Airport Moving Map Alert

Subject: Zagreb, Croatia
Franjo Tudjman (LDZA)
Cycle 2604 and 2605

RWY 04/22 configuration incorrect. TWYs A, B status incorrect.

JEPPESEN
 10 APR 26 (10-8) Eff 16 Apr

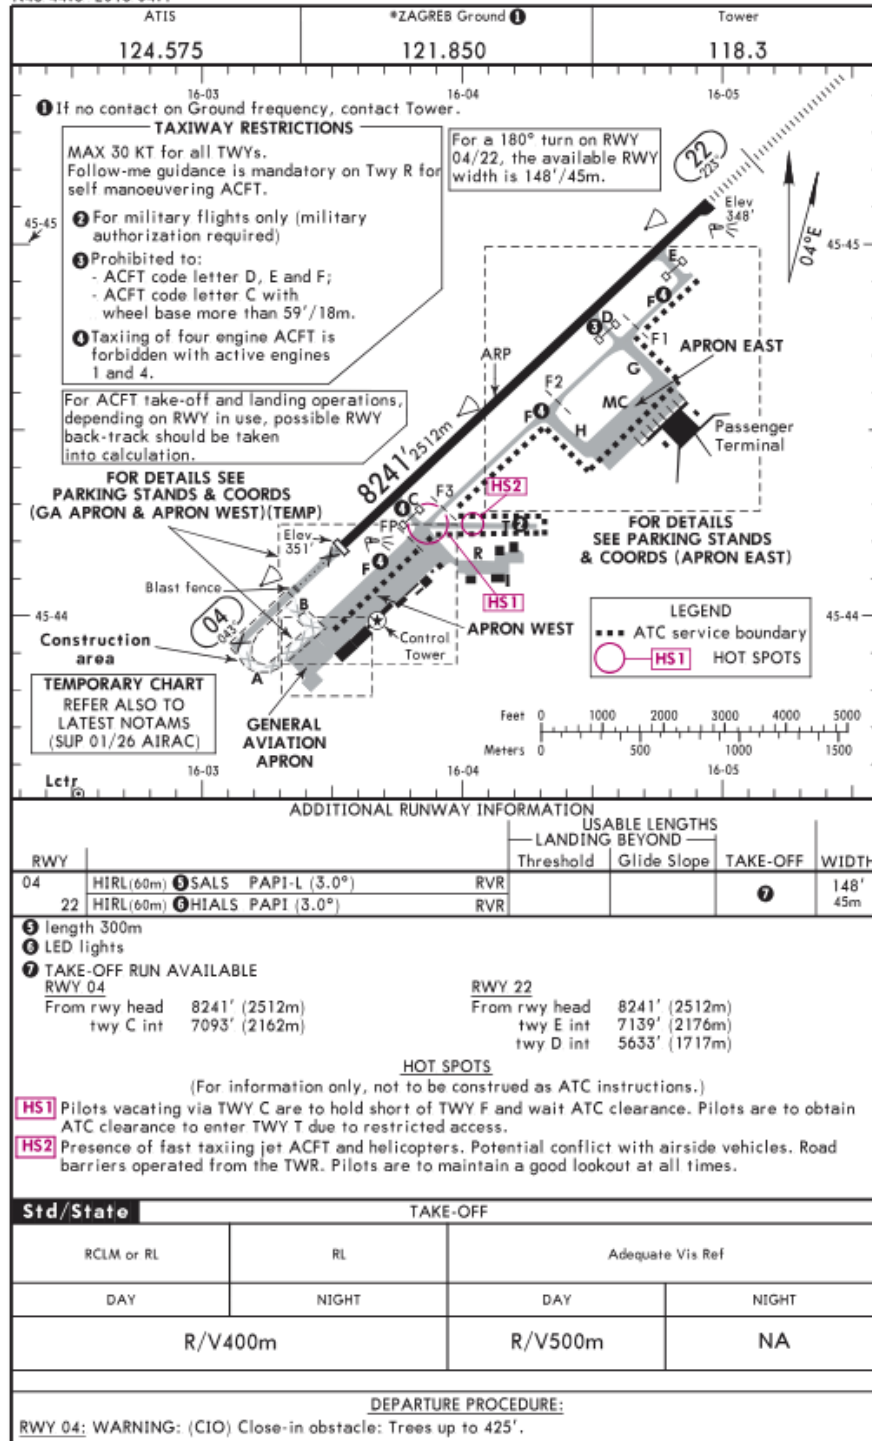
- RWY 04 is displaced by 740 meters
- RWY 04/22 length is reduced to 2512 meters
- RWY 04/22 Declared Distances should read:
RWY 04: TORA 2512m TODA 2512m ASDA 2512m LDA 2512m
RWY 22: TORA 2512m TODA 2512m ASDA 2512m LDA 2512m
- RWY 04/22 Declared Distances for intersection take-off should read:
RWY 04: TWY C TORA 2162m TODA 2162m ASDA 2162m
RWY 22: TWY D TORA 1717m TODA 1717m ASDA 1717m
TWY E TORA 2176m TODA 2176m ASDA 2176m
- Construction Area on part of closed RWY 04/22 is added
- Construction Area on TWYs A and B is added
- TWYs A and B are closed
- Temporary Taxilane WG on GA Apron is established

Revised data will appear in Jeppesen Airport Moving Map and A816 formatted data for cycle 2606, effective 11 June 2026. Until then this Alert will be posted on the Jeppesen Web site: [Notices and Alerts](#). Please refer to the local NOTAMs and Zagreb, Croatia (LDZA) 10-8, 10-8A temp charts dated 10 APR 26, effective 16 APR 26 for valid information.

JEPPESEN
10 APR 26 10-8A Eff 16 Apr

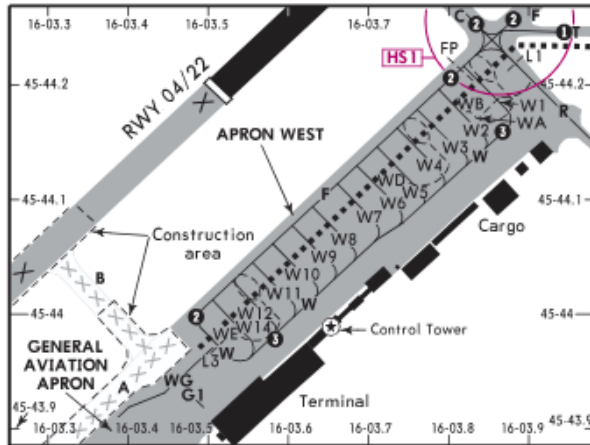
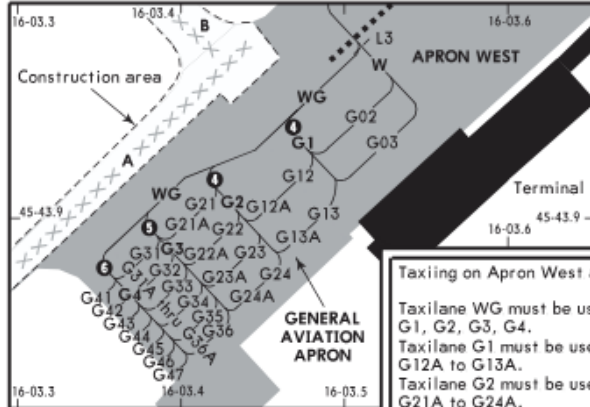
TEMPORARY CHART
 REFER ALSO TO LATEST NOTAMS (SUP 01/26 AIRAC)
